New Bedford  
514.1  
ESD

**DECLARATION FOR THE EXPLANATION OF  
SIGNIFICANT DIFFERENCES**

New Bedford Harbor Site/Hot Spot Operable Unit  
New Bedford, Massachusetts

**EXPLANATION OF SIGNIFICANT DIFFERENCES  
NEW BEDFORD HARBOR SITE/HOT SPOT OPERABLE UNIT  
NEW BEDFORD, MASSACHUSETTS**

FIGURE 2  
 CONCEPTUAL CDF COVER DESIGN

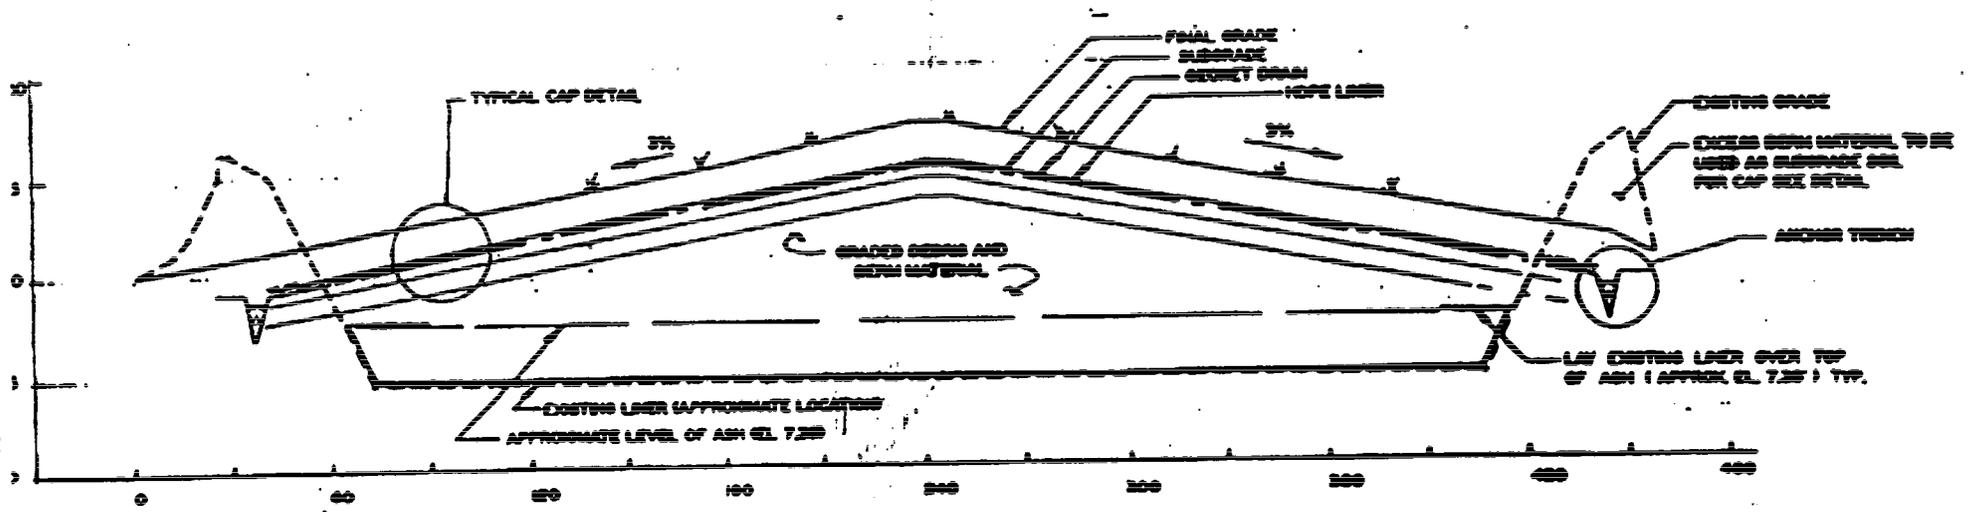
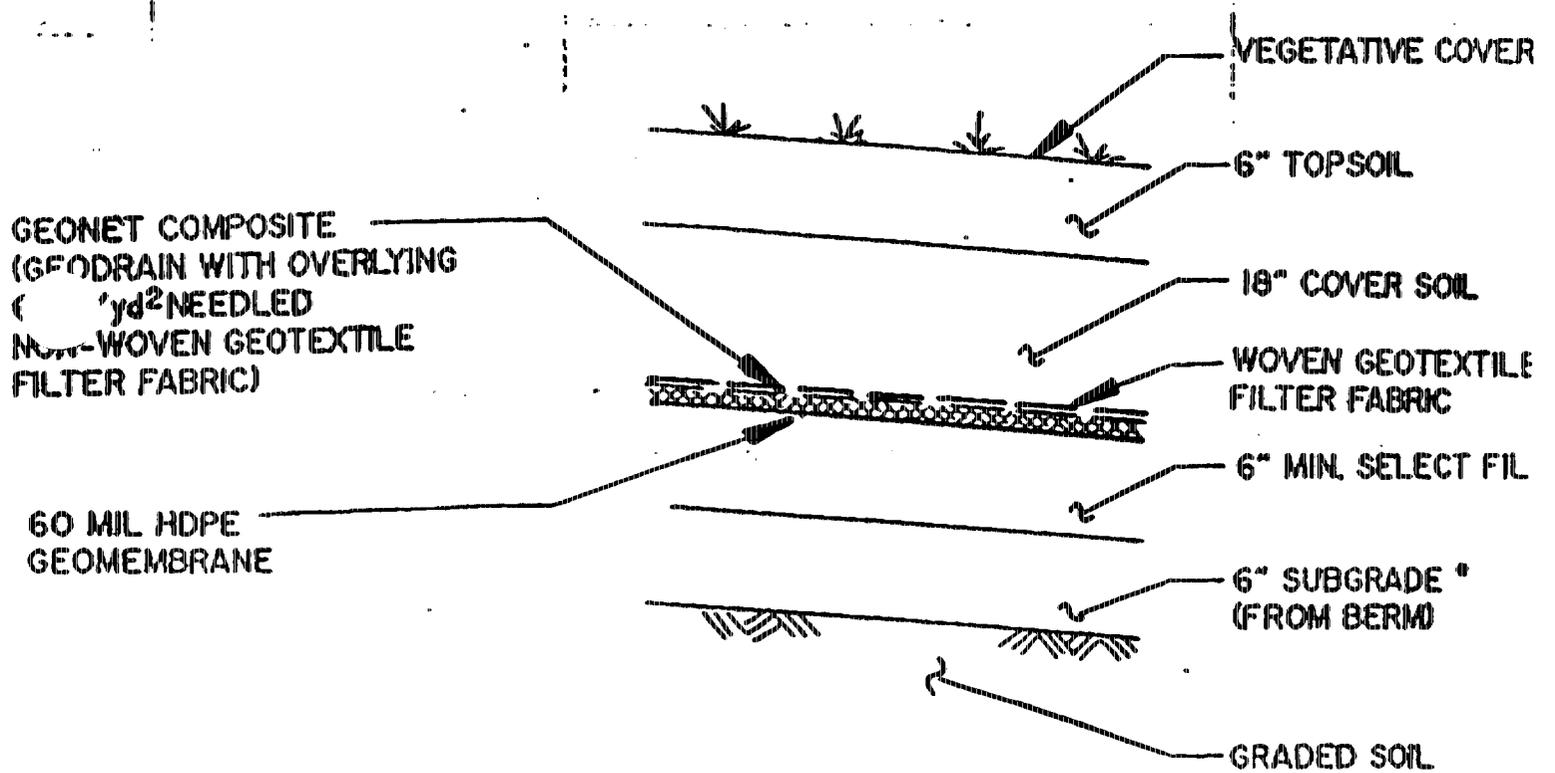
The cover for the CDF is being designed to attain the final cover closure requirements for hazardous waste landfills (310 CMR 30.633). The cover system will include a bedding layer, an impermeable flexible membrane liner (with a drainage layer) and finally, a two-foot-thick soil/vegetative cover layer. See Figures 2 and 3 for conceptual design drawings.
